INDIANA DEPARTMENT OF TRANSPORTATION

APPROVED MINUTES

March 16, 2017 Standards Committee Meeting

RE: Minutes from the March 16, 2017 Standards Committee Meeting

404-2.03(02) Permanent Metal Forms [Rev. May 2013, Rev. Mar. 2017]

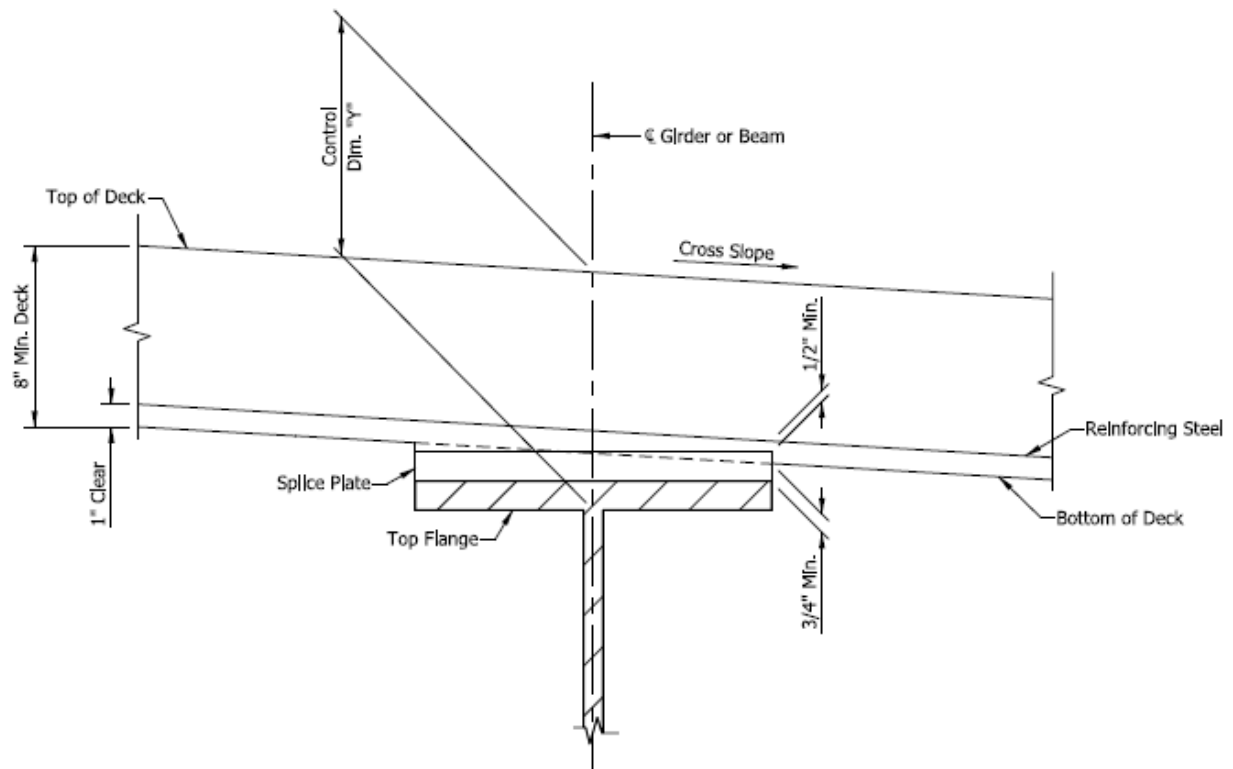
Mr. Orton, sitting in for Ms. Phillips, introduced this item stating the intention to create an RSP to limit the angle leg projection relative to the SIP form pan, and to revise the deflection requirements to be in accordance with AASHTO guidance. Ms. Wagner provided further clarification of the proposed revisions.

Design of permanent metal forms is the responsibility of the contractor in accordance with INDOT *Standard Specifications* section 702. Designers should account for the use of forms as described in Chapter 403-2.03.
